ACCESSIBILITY ASSESSMENT

DATE OF REPORT:
January 6, 2023

ADA TITLE II ASSESSMENT

GLENARDEN HILLS
3171 RONALD KEENER LOOP
LANHAM MD 20706

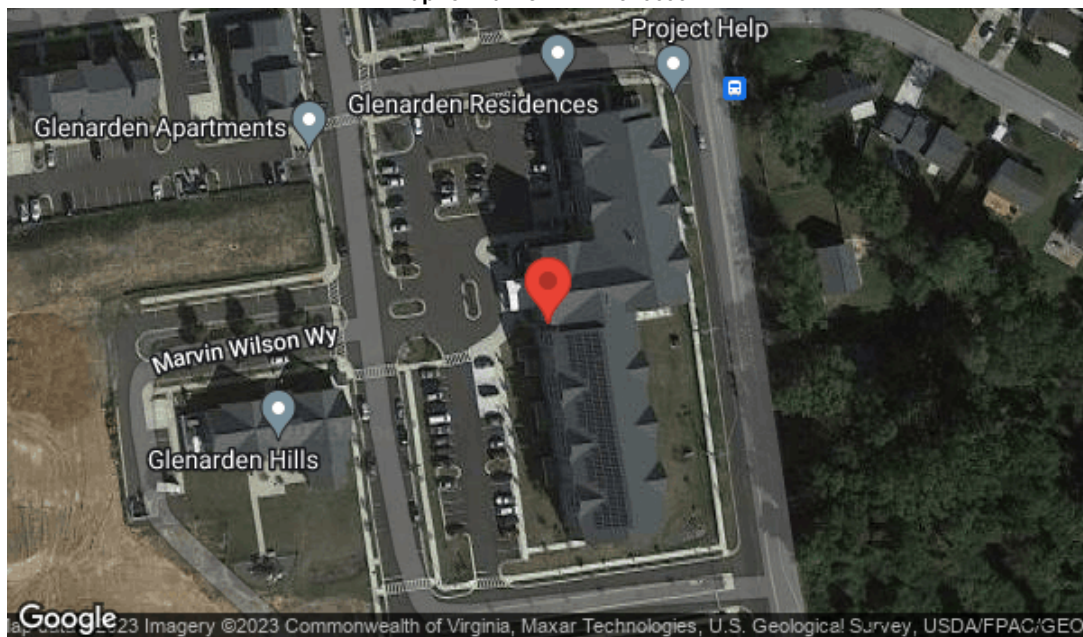
Assembly	Exterior Access Route
Type	Exterior Accessible Route
ADA Standard	UFAS 4.2.3
Barrier Detail	The accessible route does not have a compliant wheelchair turning space.
Location Description	Unit 213
Observed	Jun 8, 2022 by bscott
Site Conditions	The depth of the balcony is 59-1/2" from the face of the door jamb.

Provide a compliant turning space at the change of direction in the accessible route. The space required for a wheelchair to make a 180-degree turn is a clear space of 60" diameter (see Fig. 3(a)) or a T-shaped space (see Fig. 3(b)).

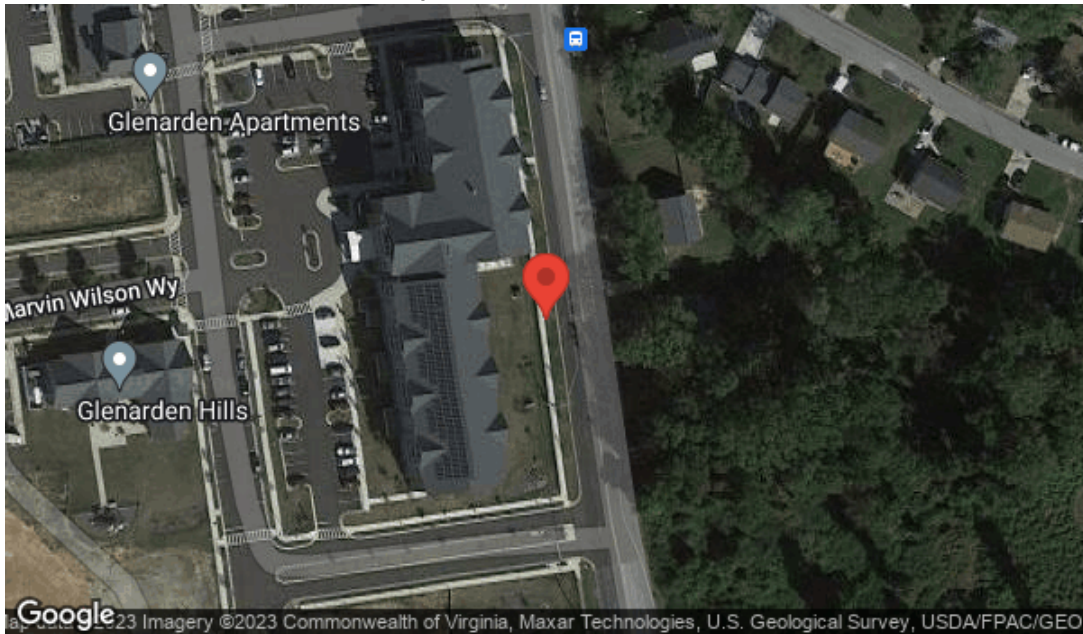
Assembly	Interior Access Route
Type	Dining And Work Surface
ADA Standard	UFAS 4.3.8
Barrier Detail	The dining surface or work surface is not compliant.
Location Description	Commons area
Observed	Jun 8, 2022 by bscott
Site Conditions	The round table bases do not allow for knee and toe clearance.

Provide a dining or work surface with the top of the surface from 28" to 34" high. The tops of tables and work surfaces shall be from 28" to 34" from the floor or ground. If seating for people in wheelchairs is provided at tables, counters, and work surfaces, knee spaces at least 27" high, 30" wide, and 19" deep shall be provided (see Fig. 45).

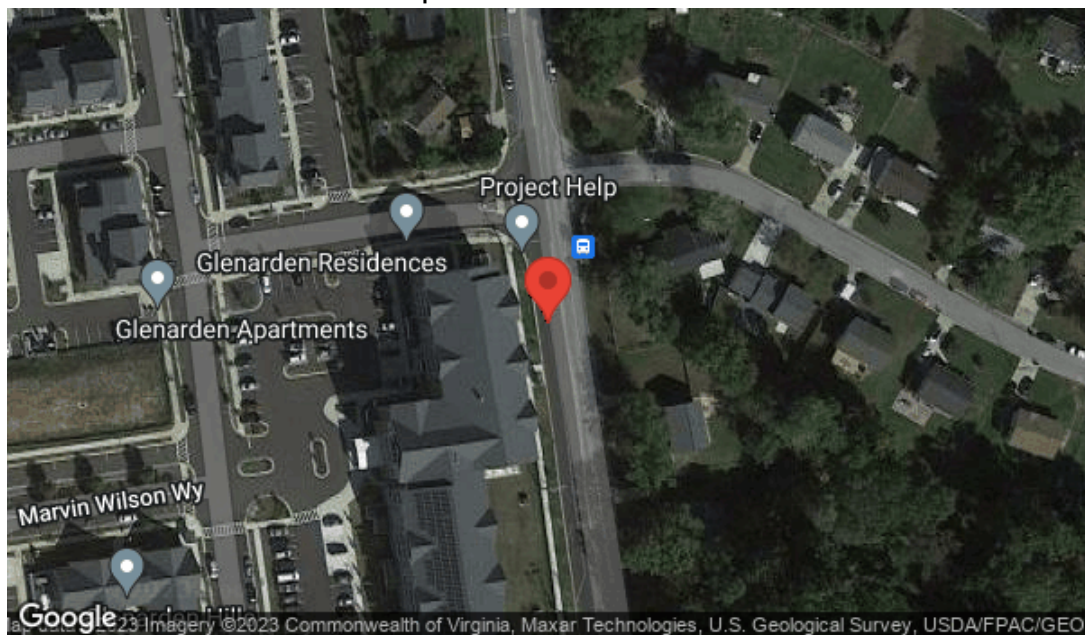
Elements that require a forward reach motion are not within the allowable reach range.

Site Conditions The security latches at the back door are 54" and 57" a.f.f.

Relocate the operable part to within the allowable forward reach range, measured from the finish floor. If the clear floor space allows a forward approach by a person in a wheelchair for an unobstructed forward reach, the high forward reach shall be maximum 48" and the low forward reach shall be minimum 15" above the floor. See Figure 5(a). If the clear floor space allows a forward approach by a person in a wheelchair for an obstructed forward reach, the obstructed forward reach is maximum 48" high, where the horizontal reach is maximum 20". The obstructed forward reach shall be maximum 44" high, where the horizontal reach is between 20" and maximum 25". See Figure 5 (b).

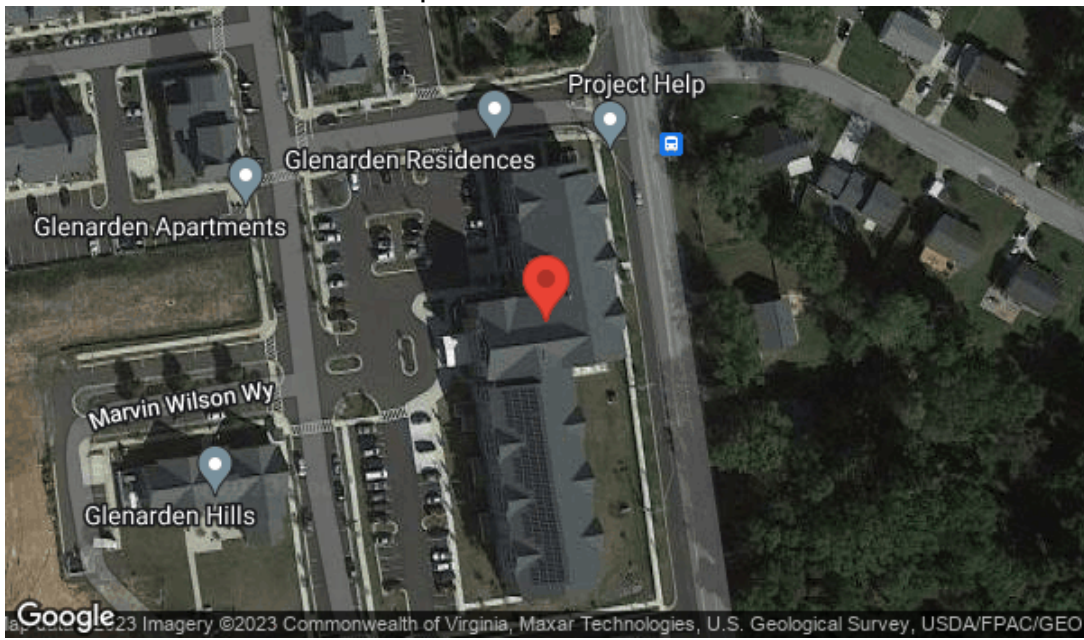
The kitchen cabinet shelving, shelf areas, and drawers are not within reach range.

Location Description	Unit 213
Observed	Jun 8, 2022 by bscott
Site Conditions	The bottom shelf of the cabinets over the workspace is 48-1/2".

Configure the shelving to provide at least one accessible shelf in each cabinet, shelf area and drawers. Cabinets, drawers, and shelf areas shall comply. Provide clear floor space at least 30" by 48" that allows either a forward or a parallel approach. Cabinets shall have the following features: (1) Maximum height shall be 48" for at least one shelf of all cabinets and storage shelves mounted above work counters (see Fig. 50). (2) Door pulls or handles for wall cabinets shall be mounted as close to the bottom of cabinet doors as possible. Door pulls or handles for base cabinets shall be mounted as close to the top of cabinet doors as possible. Shelving shall be located no higher than 48" for an unobstructed side approach or 48" for an unobstructed frontal only approach. If the clear floor space only allows forward approach to an object, the maximum high forward reach allowed shall be 48" (see Figure 5(a)). The minimum low forward reach is 15". If the high forward reach is over an obstruction, where the horizontal obstruction is less than 20" the maximum high forward reach is 48". Where the horizontal obstruction is from 20" to maximum 25", the high forward reach shall be 44" maximum. Forward obstructed reaches shall comply with Figure 5(b). If the clear floor space allows parallel approach by a person in a wheelchair, the maximum high side reach allowed shall be 54", and the low side reach shall be no less than 9" above the floor (Figure 6(a) and (b)). If the side reach is over an obstruction, the maximum horizontal reach shall be 24" and the high side reach shall be 46" maximum. Side obstructed clearances shall be as shown in Figure 6(c).

Map for Barrier ID: AX310691

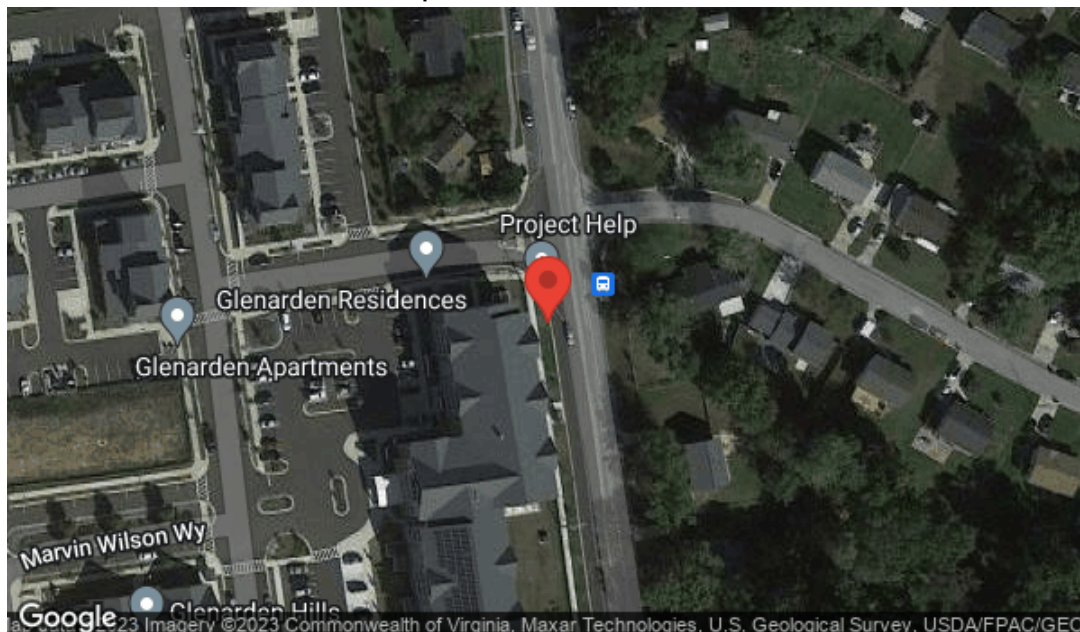
The oven is not self-cleaning or an adjustable height counter with knee space below is not located adjacent to the oven.

Site Conditions The oven is not self-cleaning, and there is no adjacent workspace to the oven.

Either Install a self-cleaning oven, or install an adjustable height counter with knee space below adjacent to the oven. Ovens shall be of the self-cleaning type or be located adjacent to an adjustable height counter with knee space below (see Fig. 52). For side-opening ovens, the door latch side shall be next to the open counter space, and there shall be a pull-out shelf under the oven extending the full width of the oven and pulling out not less than 10" when fully extended. Ovens shall have controls on front panels; they may be located on either side of the door. Controls shall be within an allowable reach range, shall be operable with one hand, and shall not require tight grasping, pinching or twisting of the wrist. The force required to activate controls shall be no greater than 5 pounds (22.2N) of force. A clear floor space at least 30" by 48" that allows either a forward or a parallel approach by a person in a wheelchair shall be provided at the oven.

Map for Barrier ID: AX310692

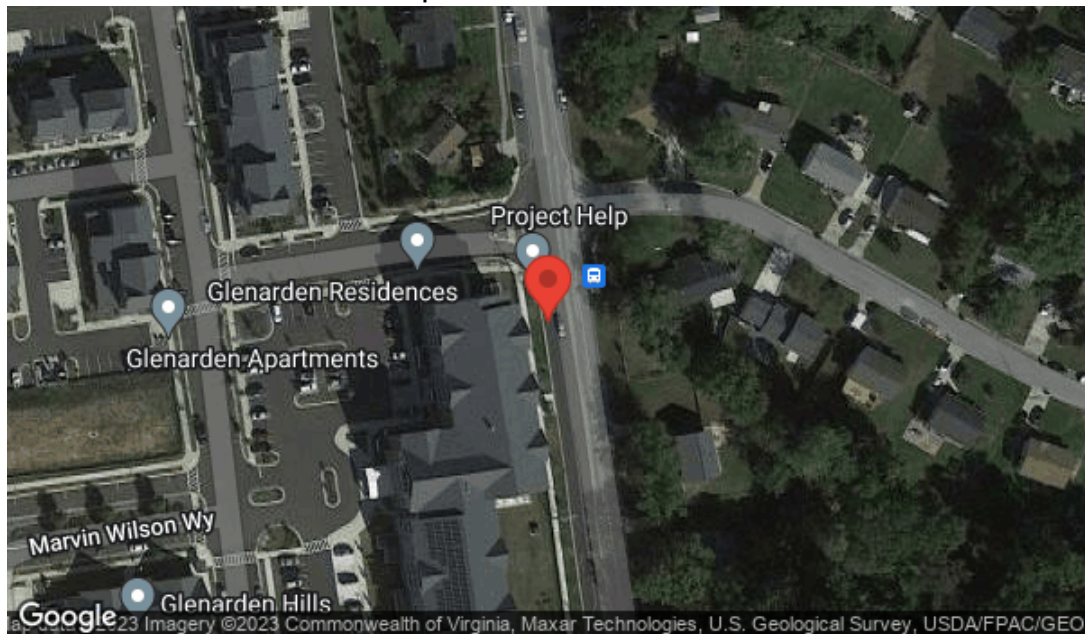
Assembly	Common Areas
Type	Restroom/Bathroom-Lavatory
ADA Standard	UFAS 4.22.6; 4.19.2
Barrier Detail	The lavatory does not have knee and toe clearance.
Location Description	Unit 104, 106, 213
Observed	Jun 8, 2022 by bscott
Site Conditions	The lavatory does not have a removable cabinet face.

Relocate lavatory to provide compliant knee clearance. Provide knee clearance of at least 29" from the floor to the bottom of the apron. Knee clearance at a height of 27" shall be minimum 8" deep. Lavatories shall be mounted with the rim or counter surface no higher than 34" above the finished floor. The lavatory shall be minimum 17" from the rear to the front edge.

Map for Barrier ID: AX310693

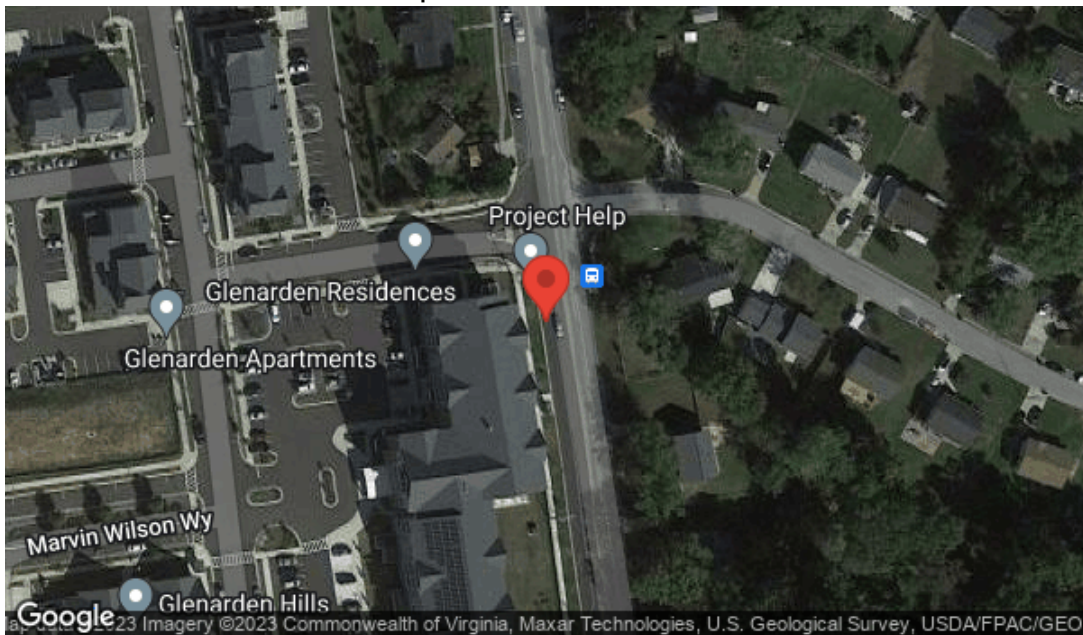
Assembly	Residential Dwelling
Type	Restroom/Bathroom-Lavatory
ADA Standard	UFAS 4.19.4
Barrier Detail	Lavatory hot water and drain pipes are not insulated.
Location Description	Unit 104, 106, 213
Observed	Jun 8, 2022 by bscott
Site Conditions	The pipes under the lavatory are not covered.

Insulate hot water and drain pipes under the accessible lavatory. Hot water and drain pipes under lavatories shall be insulated or otherwise covered. There shall be no sharp or abrasive surfaces under lavatories.

Map for Barrier ID: AX310694

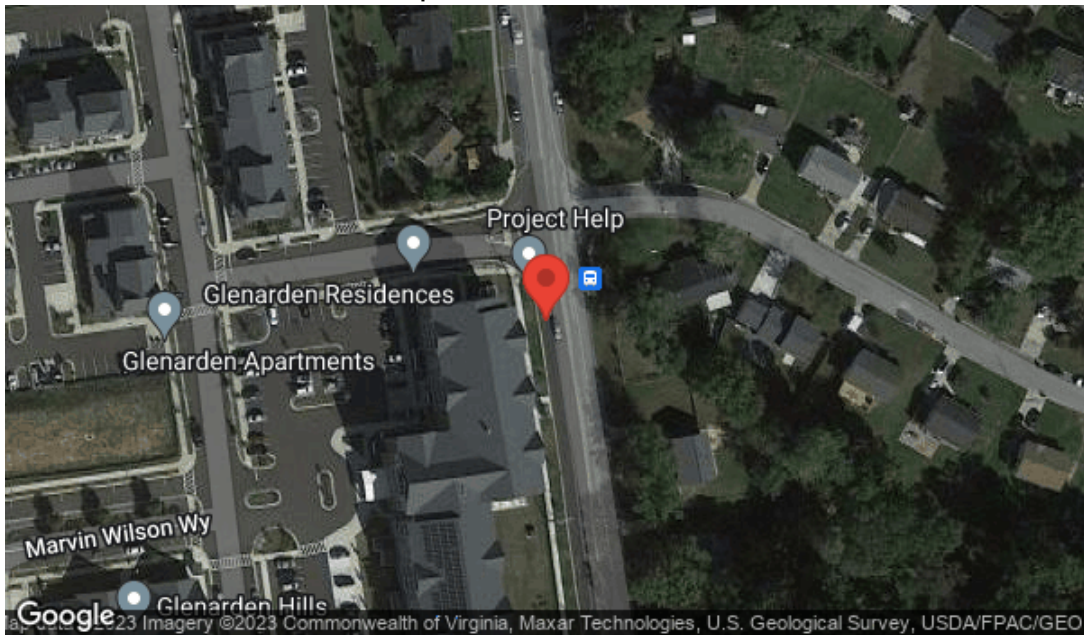
The height of the bottom of the reflective surface of the mirror is greater than 40".

Location Description	Unit 104, 106, 213
Observed	Jun 8, 2022 by bscott
Site Conditions	The reflective surface of the mirror is 41" to 42" a.f.f

Relocate the bottom of the reflective surface of the mirror to compliant height. Mirrors shall be mounted with the bottom edge of the reflecting surface no higher than 40" from the floor.

Photos for Barrier ID: AX310695

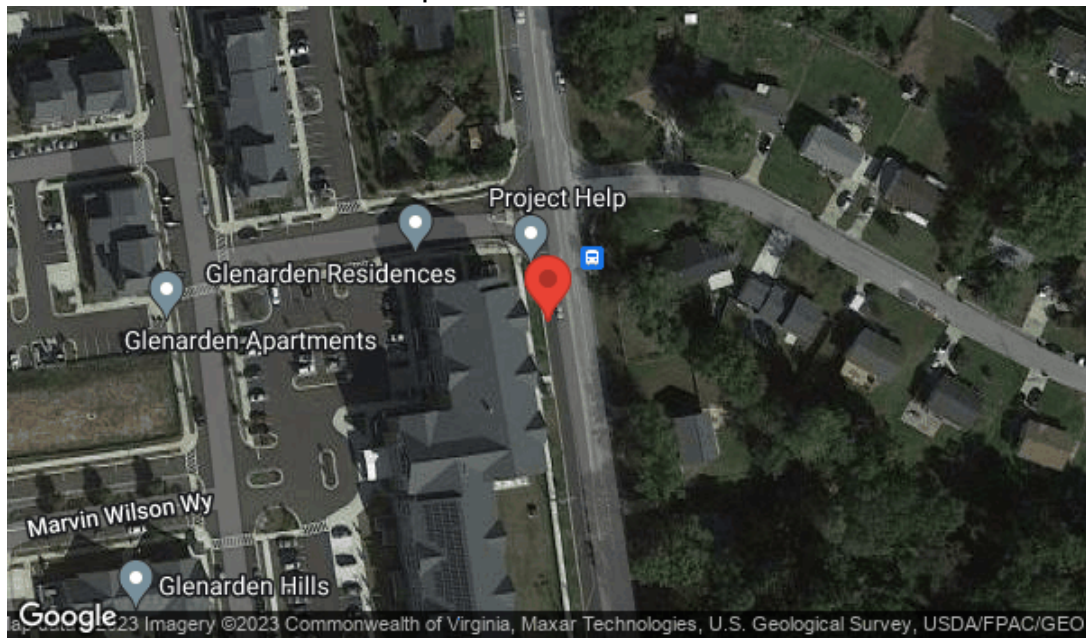
Assembly	Residential Dwelling
Type	Sink
ADA Standard	UFAS 4.34.6.5. (1)
Barrier Detail	The sink and/or surrounding counter are not compliant.
Location Description	Unit 106
Observed	Jun 8, 2022 by bscott
Site Conditions	The rim of the kitchen sink is 34-1/2" a.f.f.

The sink and surrounding counter shall be mounted at a maximum height of 34" above the floor, measured from the floor to the top of the counter surface, or shall be adjustable or replaceable as a unit to provide alternative heights of 28", 32", and 36", measured from the floor to the top of the counter surface or sink rim. The total width of sink and counter area shall be 30". Relocate sink to compliant height with knee and toe clearances. The sink and surrounding counter shall comply with the following requirements (see Fig. 51): (1) The sink and surrounding counter shall be mounted at a maximum height of 34" above the floor, measured from the floor to the top of the counter surface, or shall be adjustable or replaceable as a unit to provide alternative heights of 28", 32", and 36", measured from the floor to the top of the counter surface or sink rim. The total width of sink and counter area shall be 30". (2) Rough-in plumbing shall be located to accept connections of supply and drain pipes for sinks mounted at the height of 28". (3) The depth of a sink bowl shall be no greater than 6-1/2". Only one bowl of double- or triple-bowl sinks needs to meet this requirement. (4) Faucets shall be operable with one hand and shall not require tight grasping, pinching, or twisting of the wrist. Lever-operated or push-type mechanisms are two acceptable designs. The force required to activate controls shall be no greater than 5lbf. (5) Base cabinets, if provided, shall be removable under the full 30" minimum frontage of the sink and surrounding counter. The finished flooring shall extend under the counter to the wall. (6) Counter thickness and supporting structure shall be 2" maximum over the required clear space. (7) A clear floor space 30" by 48" shall allow forward approach to the sink. Nineteen inches maximum of the clear floor space may extend underneath the sink. The knee space shall have a clear width of 30" and a clear depth of 19". (8) There shall be no sharp or abrasive surfaces under sinks. Hot water and drain pipes under sinks shall be insulated or otherwise covered.

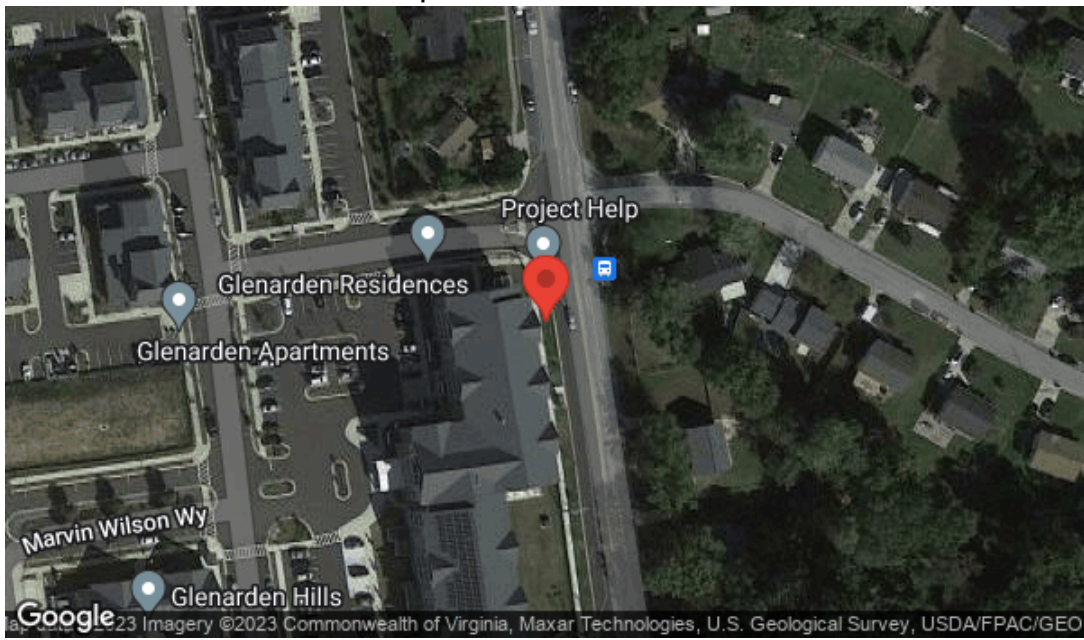
Assembly	Residential Dwelling
Type	Controls And Dispensers
ADA Standard	UFAS 4.2.5, 4.2.6, 4.27
Barrier Detail	The controls and operable parts are not within an allowable reach range.
Location Description	Unit 106, 213
Observed	Jun 8, 2022 by bscott

Each counter section must have one electrical outlet within reach range. The electrical outlets are 24-1/2" to 26" from the counter's edge.

Provide controls and operable parts within an allowable reach range. A clear floor space 30" by 48" shall be provided that allows either a front approach or a parallel approach by a person using a wheelchair at controls, dispensers, receptacles, and other operable equipment. If the clear floor space only allows forward approach to an object, the maximum high forward reach allowed shall be 48" (see Figure 5(a)). The minimum low forward reach is 15". If the high forward reach is over an obstruction, where the horizontal obstruction is less than 20" the maximum high forward reach is 48". Where the horizontal obstruction is from 20" to maximum 25", the high forward reach shall be 44" maximum. Forward obstructed reaches shall comply with Figure 5(b). If the clear floor space allows parallel approach by a person in a wheelchair, the maximum high side reach allowed shall be 54", and the low side reach shall be no less than 9" above the floor (Figure 6(a) and (b)). If the side reach is over an obstruction, the maximum horizontal reach shall be 24" and the high side reach shall be 46" maximum. Side obstructed clearances shall be as shown in Figure 6(c). Those portions of heating, ventilating and air conditioning equipment requiring regular, periodic maintenance and adjustment by the resident of a dwelling shall be accessible people in wheelchairs. If air distribution registers must be placed in or close to ceiling for proper air circulation, this specification shall not apply to the registers.
